CONSENT ITEM
MCPB 10/26/06

MEMORANDUM

REVIEW TYPE: Site Plan Amendment Review
PROJECT NAME: Parkside
CASE #: 82003000A
APPLYING FOR: Approval for site plan amendment to revise landscape and lighting details and remove noise attenuation fence.
REVIEW BASIS: Div. 59-D-3.7. of Montgomery County Zoning Ordinance.
ZONE: R-200 (3.17 acres) and RMX-2 (8.48 acres)
LOCATION: Clarksburg Road (MD 121), 2100 feet east of Frederick Avenue (MD 355).
MASTER PLAN: Clarksburg
APPLICANT: Miller and Smith
FILING DATE: February 13, 2006
HEARING DATE: October 26, 2006

Unmitigated Future ON & CONTOUR

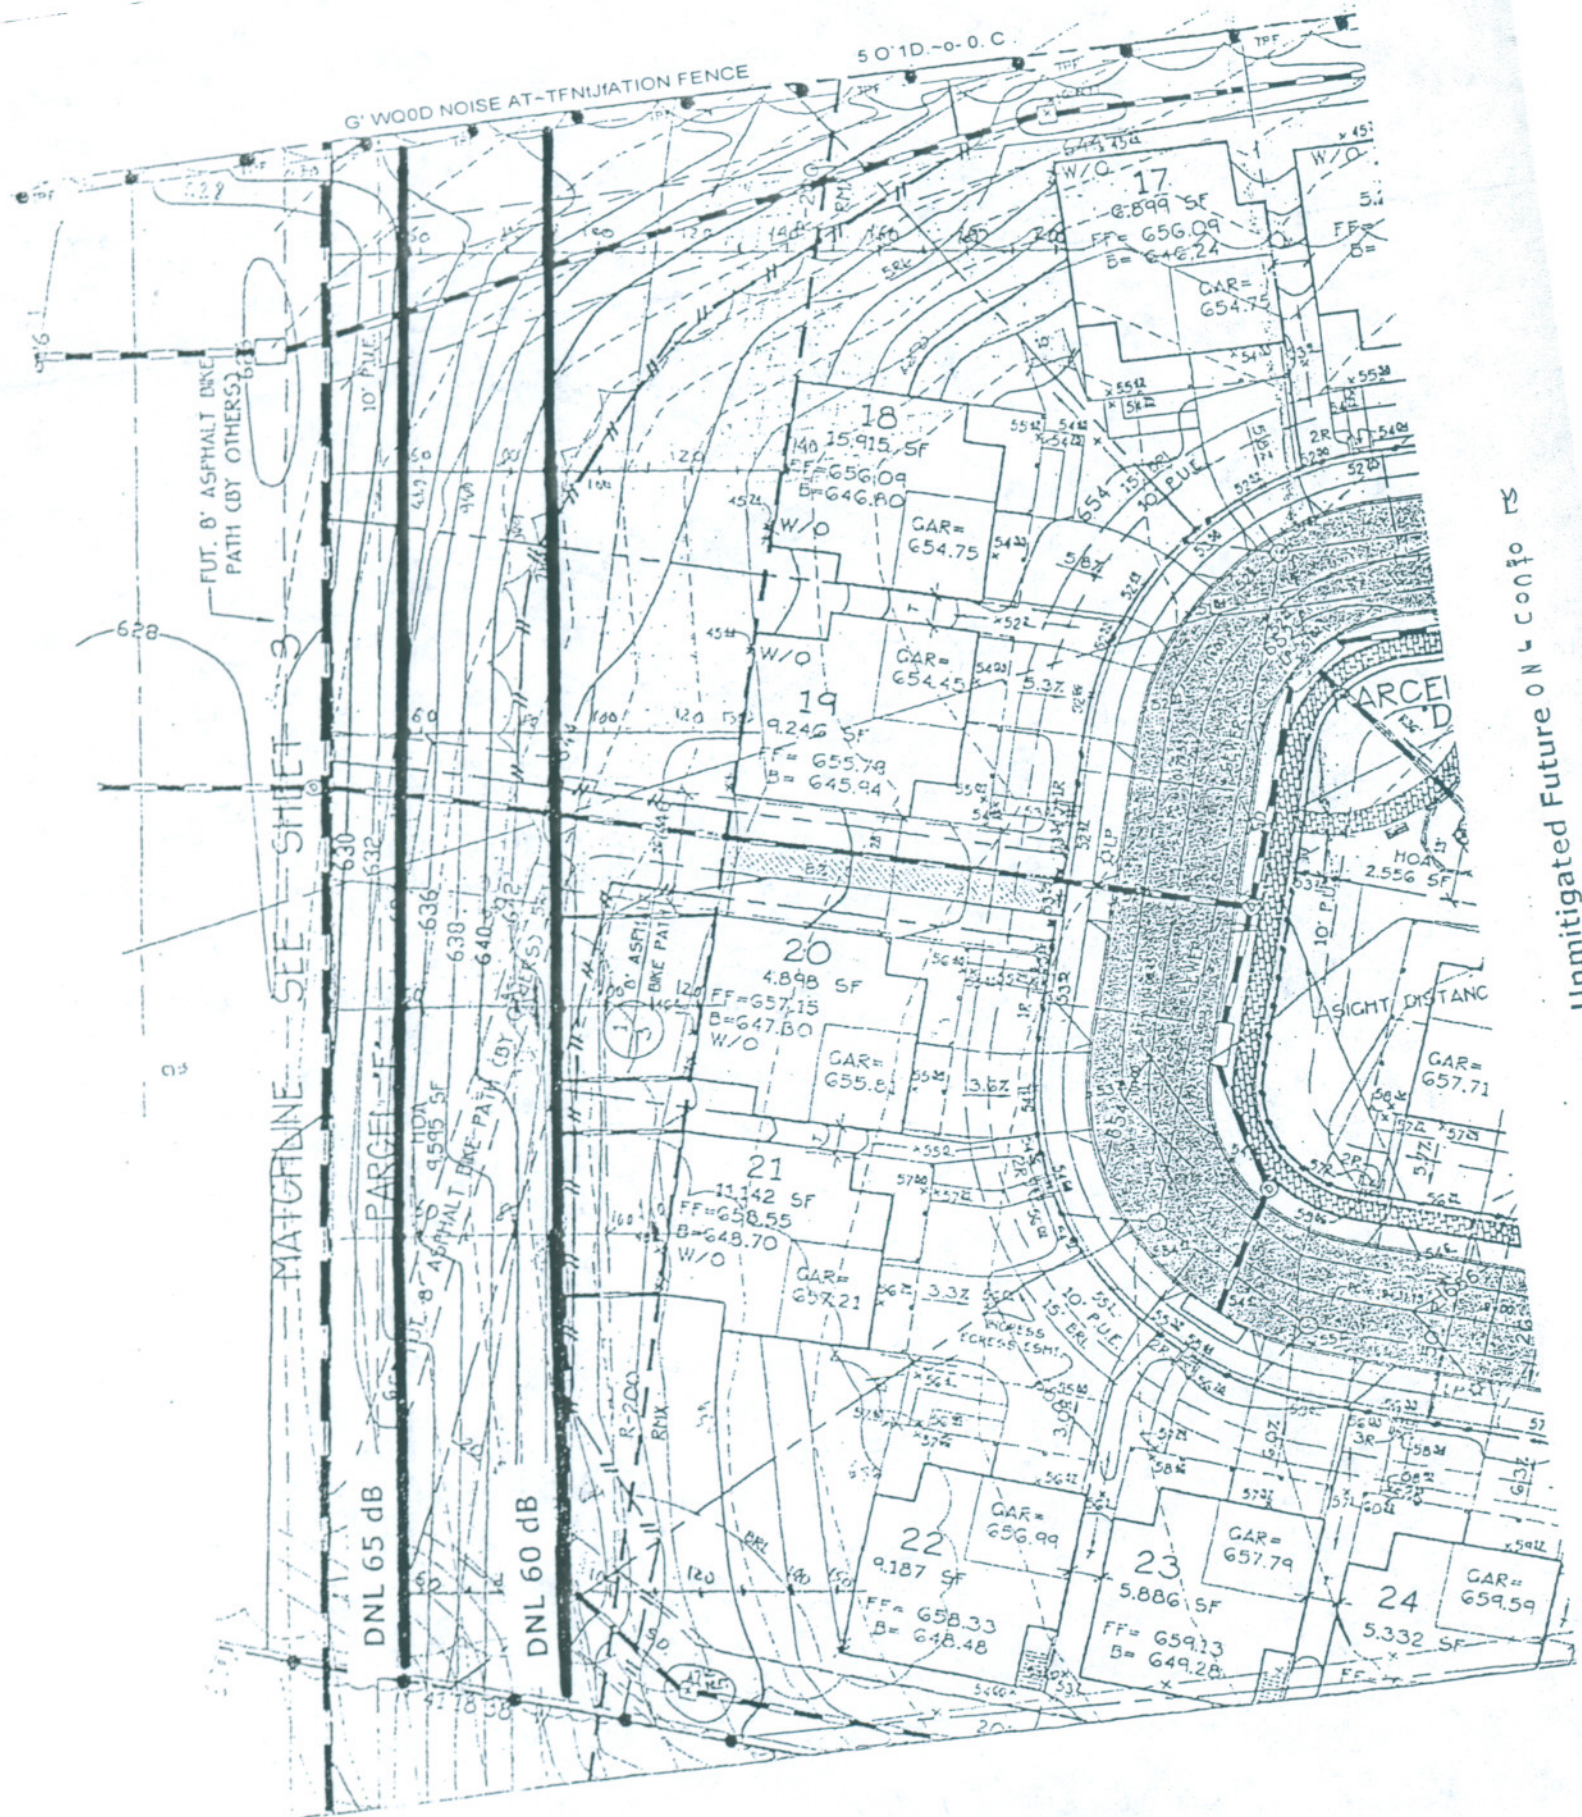
The unmitigated future DNL in rear yards, without noise barriers, are presented in Table 2, rounded to the nearest 0.5 dB. The unmitigated future DNL contours of 65 dB and 60 dB at five feet above the proposed ground elevations are shown in Figure 1.

It can be seen from Table 2 and Figure 1 that the future DNL will not exceed the M-NCPPC limit of 65 dB in any of the rear yards. The unmitigated future DNL contour of 65 dB is located at a distance of approximately 57 feet from the A-305 centerline.

The unmitigated future DNL contour of 60 dB is located at a distance of approximately 90 feet from the A-305 centerline, as can also be seen from Figure 1. It is expected therefore that the future DNL in the rear yards of the proposed lots will not exceed 60 dB, with the exception of a part of Lot 19 nearest to the road, where the DNL may reach 61.5 dB.

As the result, with all the conservative assumptions made in the current analysis, the future DNL is not expected to exceed the 65 dB outdoor limit. In this situation, we do not consider constructing the noise barrier (attenuation fence) along the rear

yard line, as indicated on the site plan, necessary to meet the M-NCPPC outdoor noise limit.
